Thor Motor Coach Technical Information Bulletin

TIB # 14-003

Issue: On certain 2014 Tuscany 44MT units, the tile was not run far enough towards the edge of the floor at the front of the driver's side slide out. This may cause the slide roller to fall off of the edge tile when the room is fully extended. This may lead to damage to the tile and/or slide roller.

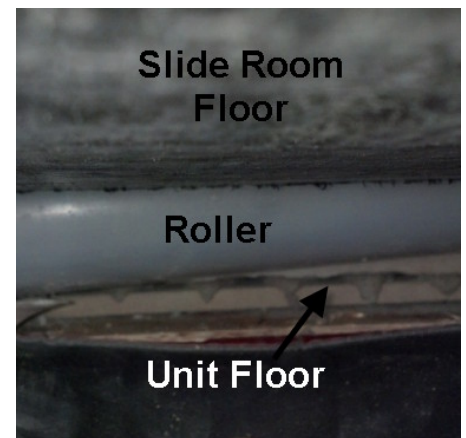
Photo to the right shows the roller falling off the edge of the tile before any repair work is done

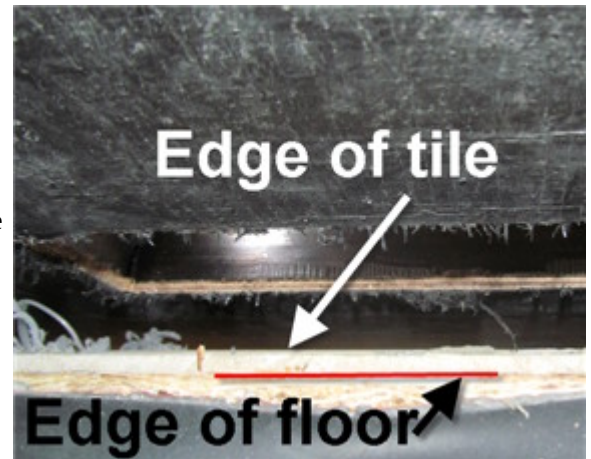
Measure the gap between the edge of the floor at the side wall and where the tile begins. If this measurement is more than 1", proceed with the repair. If the measurement is less than 1", this repair is not needed.
